Reply to Reviewer Comments

Reviewer 2:

C1: In this study, seismic sensors have been used to investigate three debris flow events that occurred in the Fotangbagou and Ergou catchments, in Wenchuan (China). The authors combined seismic observations with rainfall measurements, photos by infrared cameras, and a post-event survey to get additional information on the debris flows. The velocity of the debris flows has been estimated through the seismic signals recorded at different stations and then compared with results from the application of the Manning formula, while the relative magnitude of the events has been inferred after taking into account the decay of the seismic energy during propagation. The topic addressed here is relevant and within the scope of ESurf, as although seismology has been used to monitor debris flows for decades, the link between the seismic signature and the properties of the events still needs to be properly understood. The quality of the seismic data is good, and the study areas seem interesting. However, I find the current state of the manuscript far from being considered for publication. My major concerns are (i) the large gap between the aims raised by

Fig. 1. Overview of the study area. (a) Location of the study area within China; (b) The two study catchments, Ergou and Fotangbagou, on the Minjiang River, Wenchuan, Sichuan, China.

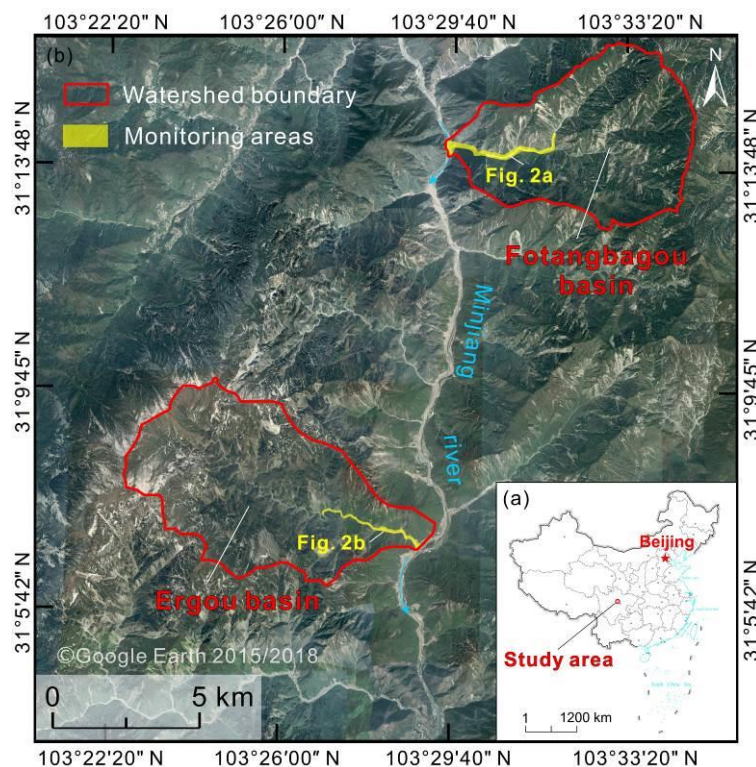
C32: Figure 1: I'm not sure that Figure 1c is necessary, since you do not mention the geology of the area with this precision. If you remove the panel and all the legend, Figure 1a and 1c could gain some space. In the caption of the figure, say that the catchments of interest are in red. I don't get Google Earth 2015/2018: why these two years?

R32: We thank the reviewer for this comment. We also think Figure 1c is unnecessary, so Figure 1c, the panel and all the legend were deleted. The catchments of interest in red also have been explained in legend. Satellite images in 2015 and 2018 are the newest available for the study area. Because the area is too broad, satellite images of this area in 2015 or 2018 are incomplete. Thus, Figure 1b is drawn from the combination of two satellite images of 2015 and 2018. The figure has been modified, as follows:

Fig. 3. Research methodology for processing and analysis of debris flow seismic signal.

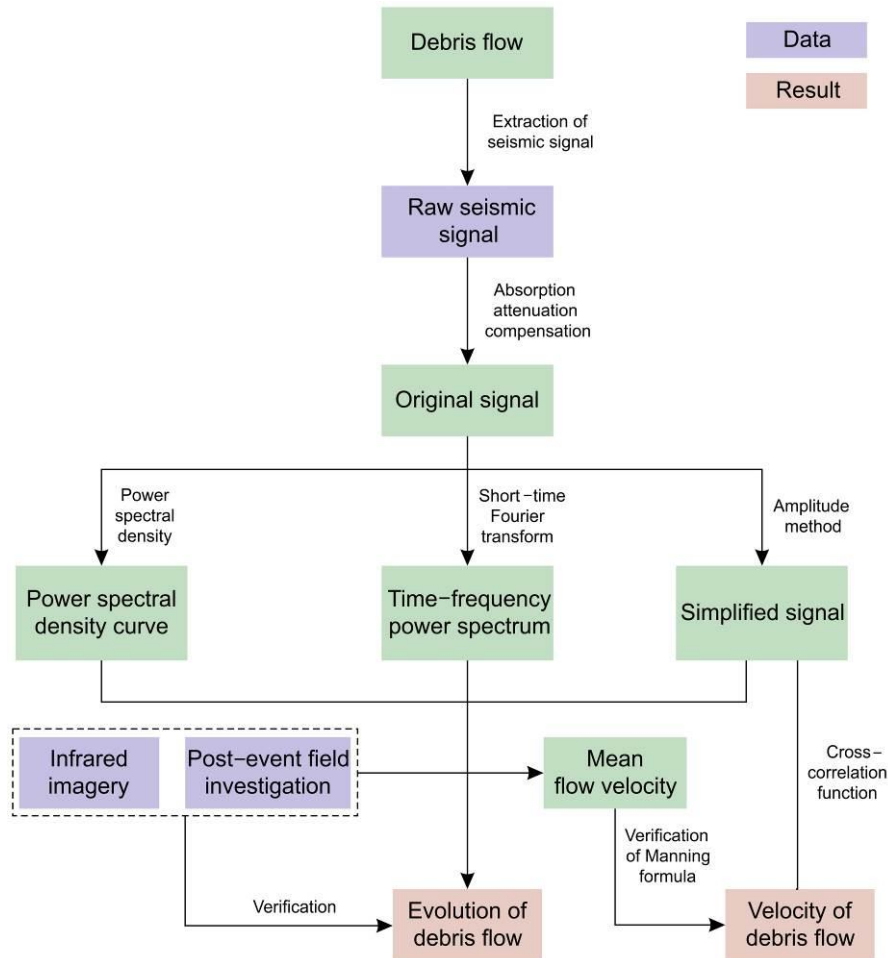
C41: The workflow in Figure 3 is not clear to me. Please follow the suggestions of the other reviewer

R41: Thank you for the useful advice. We have modified this workflow and added some simple explanation of the workflow in the beginning of the methodology. It has been modified, as follows:

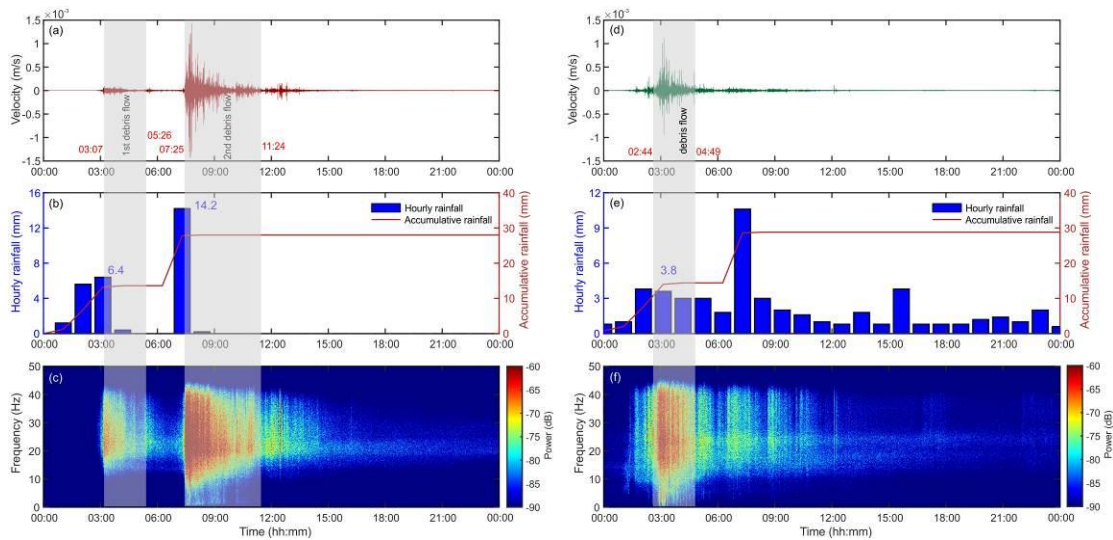
C51: Section 4.1: It is not clear to me if you know that these three debris flows occurred from other independent observations or just from the seismic observations. In the latter case, you should convince the reader that all these events are debris flows and not just intense sediment transport events. It would be also a way to highlight the usefulness of the seismic sensors. Maybe from some critical rainfall thresholds already observed in these catchments? On the other hand, if you know they were debris flows from other observations, please clarify it. For this reason, I should start the section by commenting on the rainfall measurements, and only then on the spectrograms. I propose you to merge Figure 4 and 5 in order to see (or not) the match between rainfall and peak seismic power, because now it is hard to follow your comments.

The match between rainfall and peak seismic power in Figure 4 and 5 has been modified in Fig. 5, the previous two figures have been combined to show in Fig. 5.

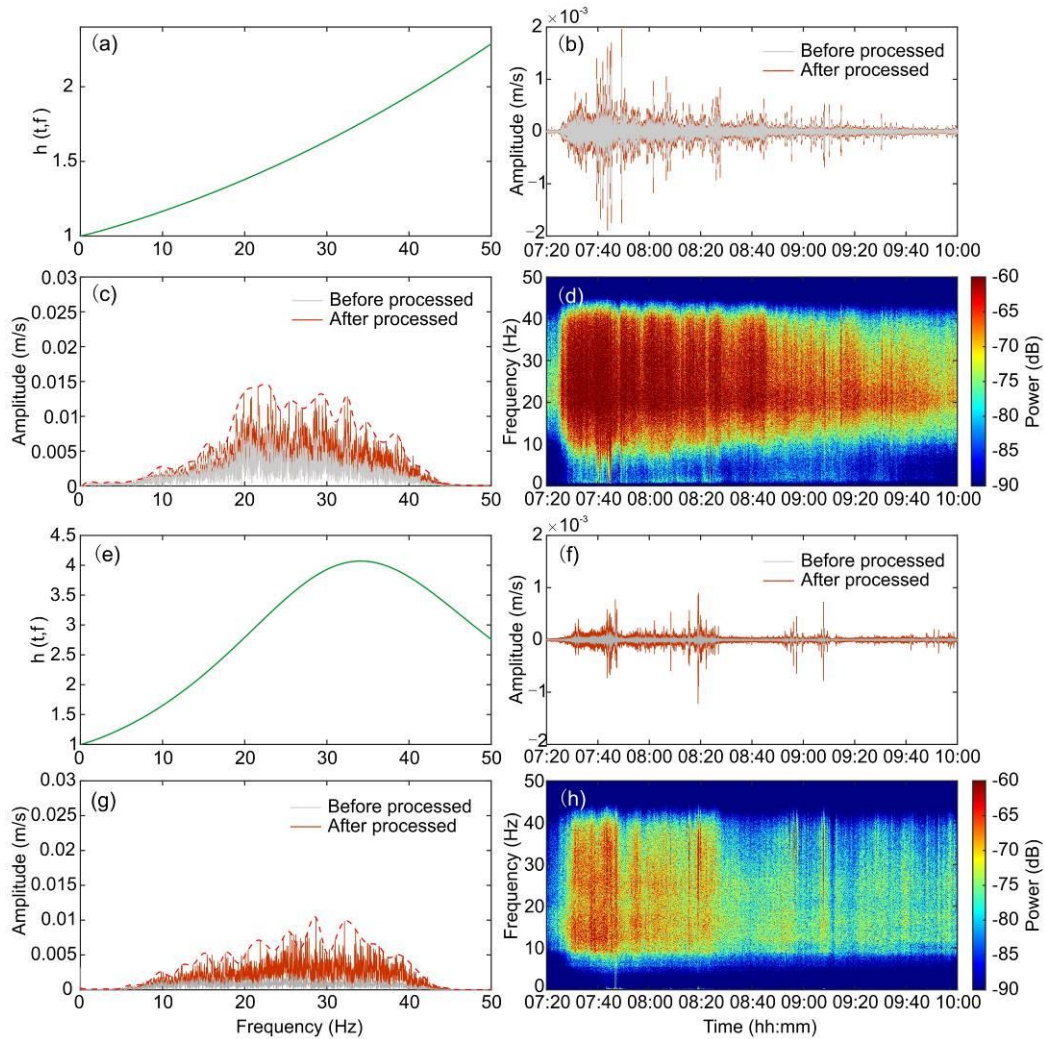
C58: Figure 6: more comments are needed for this figure. Why the function h is so different between a site to another? How do you interpret it? Please check the caption, I think that the number of the monitoring stations are not always correct. I also suggest to use spectrogram instead of “time-frequency domain energy spectrum”, which is also different from the vocabulary used in Figure 4

R58: Thank you for your useful advice. Monitoring instruments are installed around the interesting channel, geology condition between the channel and bed are complex. For hard rock especially, surface of earth has a weak absorption attenuation effect for seismic wave, so the value of Eq. (8) is small and Q is small, Eq. (8) is closer to the mathematical derivative state of keeping the attenuation function. Instead, for loose accumulation materials, surface of earth has a strong absorption attenuation effect for seismic wave, compensation coefficient of high frequency signal is big. Signal to noise ratio of high frequency signal of seismic wave is small. The energy with bigger compensation coefficient is dominated by noise after compensation, which would affect the signal to noise ratio, so we add a stability control factor σ to keep the stability of high frequency part. The number of the monitoring stations in the caption of Fig. 6 are not correct indeed, which has been modified. All the related words “time-frequency domain energy spectrum” have been modified into “spectrogram”.

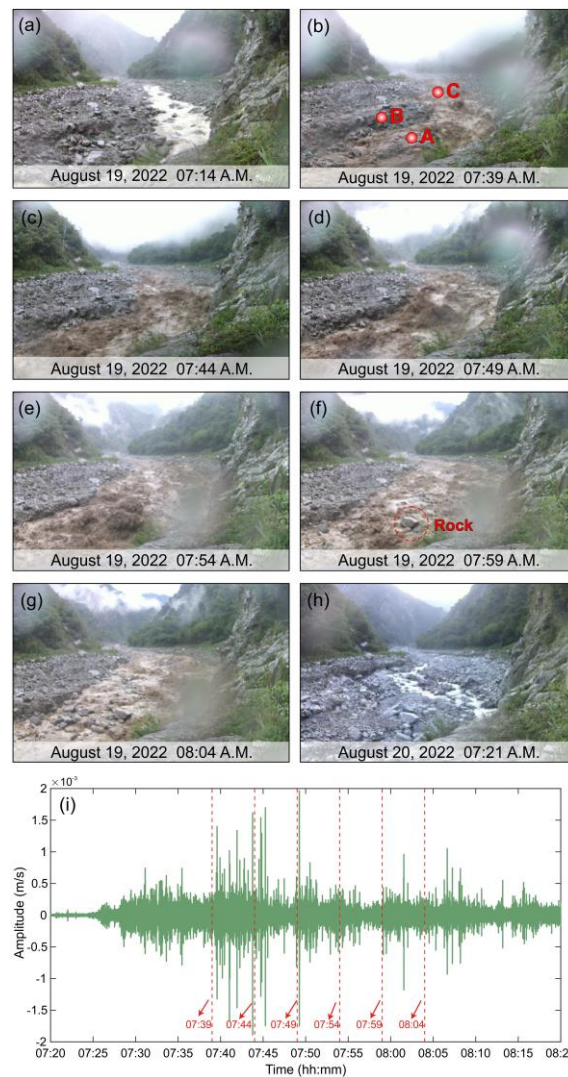
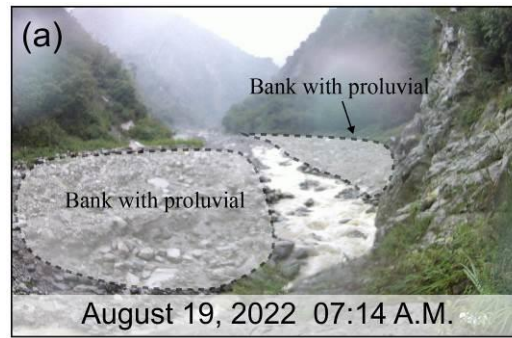
C63: Section 4.2.2: I find the use of the infrared camera interesting and I acknowledge your effort to get the maximum information possible from the images. However, I find most comments on the figure too speculative. How can you observe an increase in particle content from Figure 8a to 8d? How can you say that the flow velocity increases if images are static? I cannot see signs of erosion of the left bank you mention at line 388, and how can you see that the channel is smooth at point C (line 394)? I don't see a decreasing velocity after 7:39 (line 396), and the presence of a rock at point A is not sufficient to conclude that the transport capacity is low (lines 412-413).

C64: I honestly believe that these images can be used to identify the passage of the debris flow, and maybe to get some insights on the flow stage, but any comment on flow velocity and concentration is too vague to me.

Why have you analyzed only images from 7:39 to 8:04 given that the debris flow lasts longer? I think it is crucial to see the condition of the channel before the development of the debris flow. I suggest you to mark different part of the section before the debris flow (e.g. banks, sediment deposits), so that we can better visualize the changes and the magnitude of the event. It is also important to see images after the event: I wonder if the big rocks we see in Figure 8f are carried by the flow or just deposited.

R63: Thank you for the constructive suggestion. We can only achieve semi-quantitatively analysis after changing the structure of the manuscript, so most comments on the figure are a little speculative. We can estimate the concentration of the debris flow and whether flow is torrential or steady in infrared imageries to get the comments mentioned by you. Maybe the point A and C were marked mistakenly so

the previous comments were not clear to you. We have changed the location of point A and C in the figure. It has been modified in the section “Infrared imagery analysis”, as follows:

R64: Thank you for your professional comments. We can get the velocity of the flow from the Manning formula, Guo et al. (2016) also used this method to estimate the velocity of the flow. The concentration can be estimated from the amounts of grains and the shade of the color of the flow.

The 6 images from 7:39 to 8:04 correspond to characteristic of the strong time-domain seismic signal at the 6 frames, these images are representative to analyze characteristic of debris flow. We have marking different part of the section before the debris flow (Attached figure 1), this figure is modified from Fig. 7a and not shown to avoid affecting clearness of the figure in the manuscript. Banks of the channel are covered with proluvial, which is from the previous debris flow or collapse. Images before and after the event are shown in Fig. 7a, 7h, which can help us to visualize the changes and the magnitude of the debris flow better. It revealed that the big rocks we see in Fig. 8g are carried by the flow.

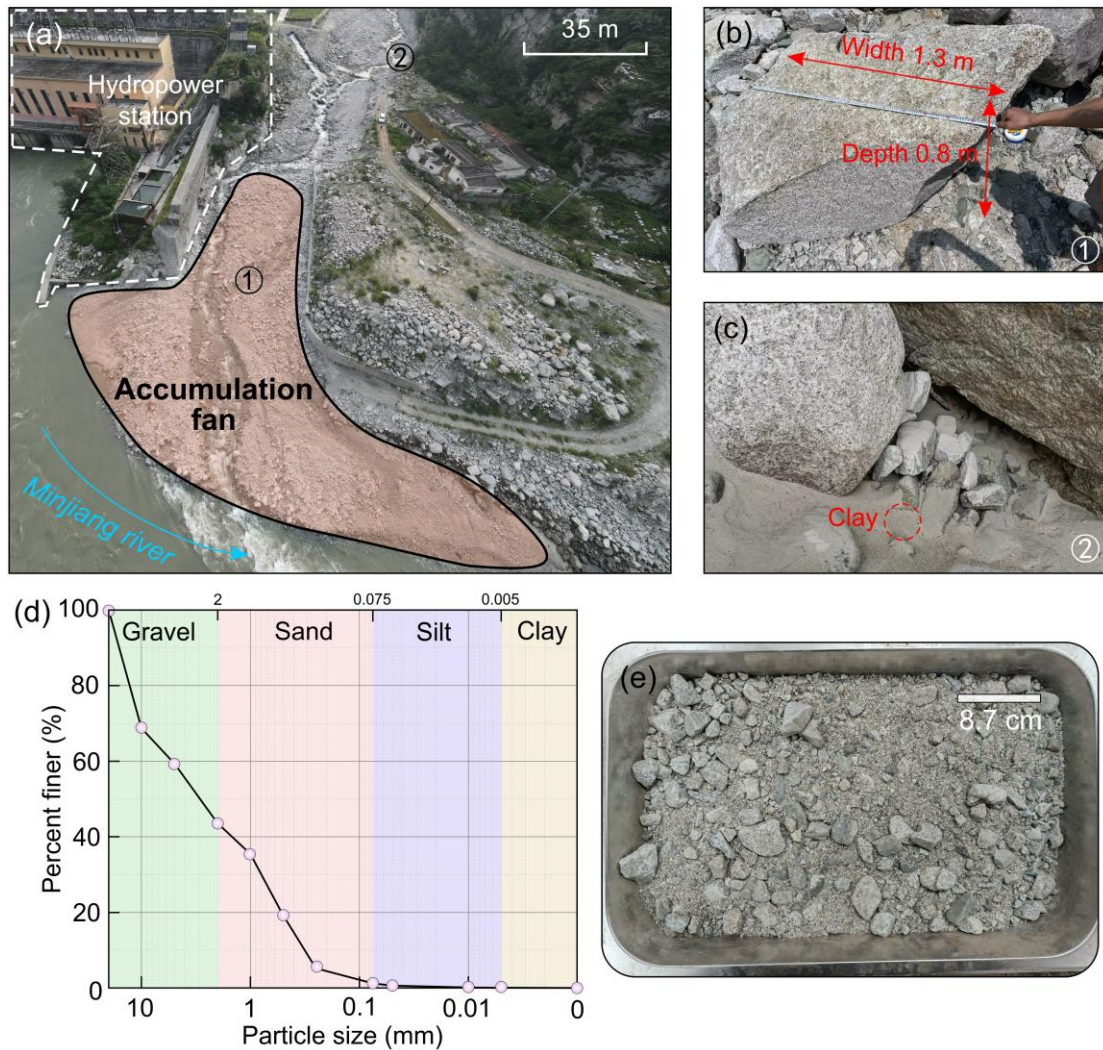
C67: Lines 424-426: these sentences are vague. In Figure 9c I still see very big rocks. Moreover, the fact that at a very specific point of the fan there are some small particles, doesn't mean that the carrying capacity of the debris flow sharply decreases. I suggest you to remove this part.

C68: Lines 427-438: please specify that from your sample you can only quantify the small fraction of the deposit. For the same reason, it is not correct to say that the 94th percentile of the grain size distribution is 0.018 m: look at the big rocks in the photos.

C69: Figure 9: In Figure 9a you use “deposition fan”, in the caption you use “accumulation fan”. Please choose one of them.

1. This part can explain the grain about the sample we collected from the accumulation fan instead of the debris flow. It is correct that the 94th percentile of the grain size distribution is 0.018 m for the sample because the big rocks are not in the sample.

2. The particle size distribution shows that 94% of the particle size of the sample is 0.018 m, i.e., D in Eq. (6). The value helps us to determine grain size of 0.01, 0.015, 0.02 and 0.025 m in PSD of Fig. 9b, because the four values are determined around 0.018 m. We used much bigger values in the previous manuscript. In order to get close to 0.018 m, we have modified grain size of 0.5, 0.55 and 0.6 m into grain size of 0.01, 0.015, 0.02 and 0.025 m.

R69: Thank you for your useful advice. The figure has been modified, as follows:

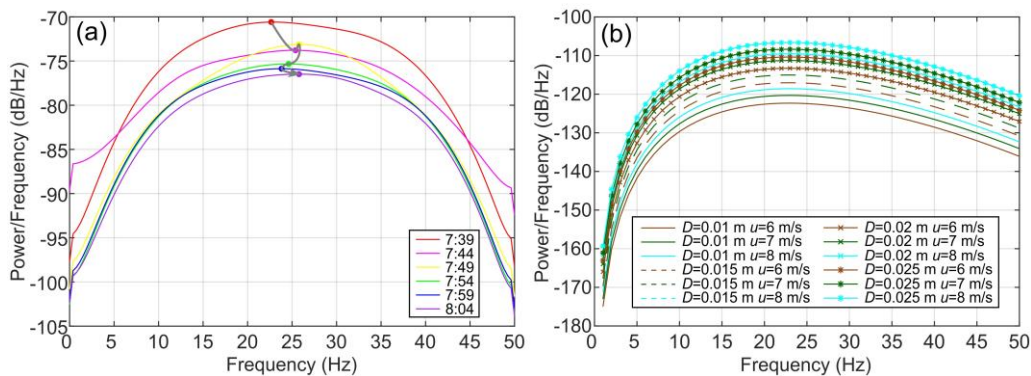
C70: Section 4.2.4: I'm sorry but I'm not sure about the need of this section. The changes you claim to see in Figure 10 are really small, especially from 7:44 to 08:04, maybe less than 1 decibel. I believe that this can be within the errors associated with your computations. If you want to investigate the variation of frequency over time, maybe you could compute the frequency peak or the mean frequency as in Farin et al.

Eq. (6) was employed to calculate the seismic Power Spectral Density (PSD) curves for the six-time points corresponding to the infrared images (Fig. 9a). Notably, the maximum energy within the main frequency band (15~30Hz) exhibited a gradual decline from 7:39 to 8:04, evident from the discernible trend in dot changes depicted in Fig. 9a. The width of the PSD spectrum demonstrated an initial increase, followed by a subsequent decrease, showing distinct trends between the low-frequency and high-frequency bands. Specifically, the high-frequency band (>30Hz) experienced a gradual reduction from 7:39 to 8:04, characterized by a rapid decrease from 7:39 to 7:49 and a relatively slower decline from 7:54 to 8:04. Conversely, the low-frequency band (<15Hz) exhibited a substantial increase from 7:39 to 7:44, followed by a more substantial decrease leading up to 7:54, after which it roughly remained unchanged. These varying characteristics among different frequency bands underscore the need for a deeper understanding. In the subsequent sections, we will employ a debris flow seismic PSD forward model to gain a more comprehensive insight into these observations.

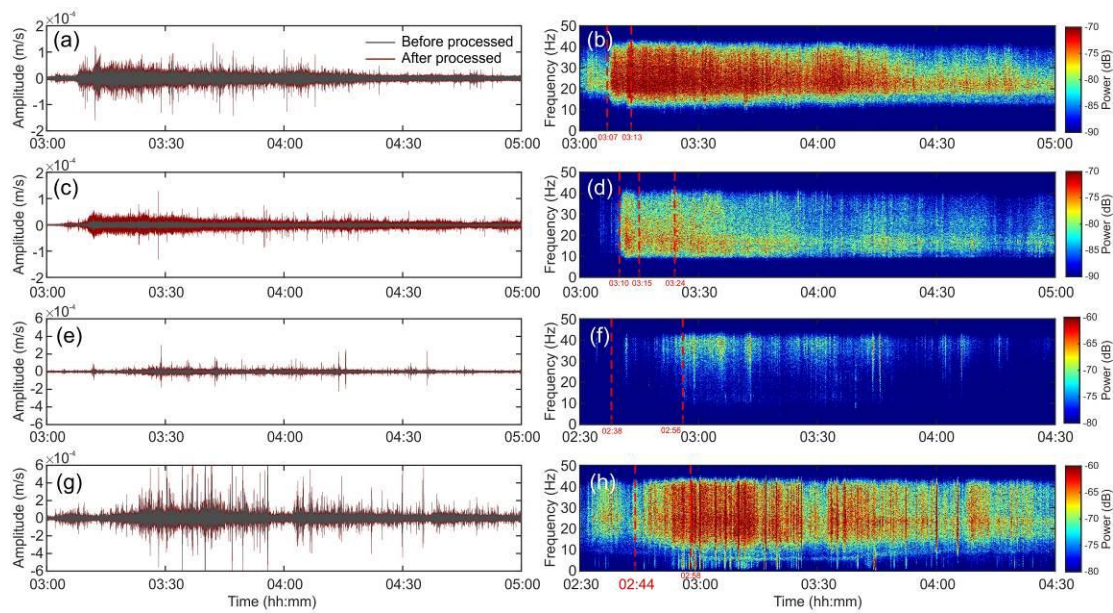
C76: Lines 522-537: it is really hard to see what you observe in the figures. I propose to show the different times with lines in the spectrograms.

R76: Thank you for spending the time to review and assess our manuscript. We have added the different times in the spectrograms of this figure, as follows:

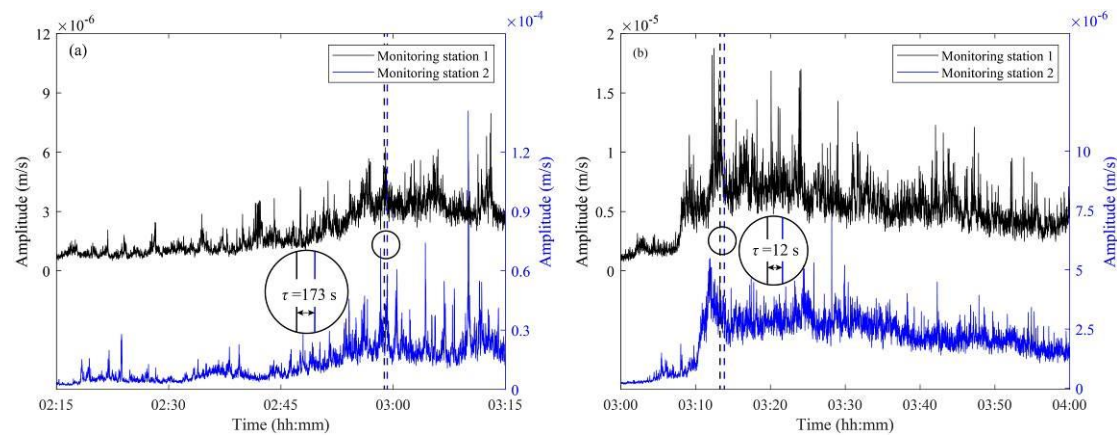
C88: Line 586: three decimal digits seem too many to me given the uncertainties.

C89: Figure 12: you should show all the three debris flows. It is not clear to me if the curves you show come from the cross-correlation routine or are just the amplitudes

R88: We deeply appreciate the reviewer carefully went through the manuscript. Three decimal digits are from the division method of the distance divided by the lag time. The uncertainties come from the division method instead of the cross-correlation function. It has been reduced to one decimal digits, which is the value of “7.0 m/s”. It has been modified, which is shown in R87 for reviewer 2 from lines 747 to 751.

Manning formula. Thus, it only has a debris flow in Figure 11. The curves I show are just the amplitudes. schematic diagram of the first debris flow in Fotangbagou gully and the debris flow in Ergou gully based on the cross-correlation function is shown as follows (Attached figure 2), the first debris flow of Fotangbagou is shown in Figure 11.
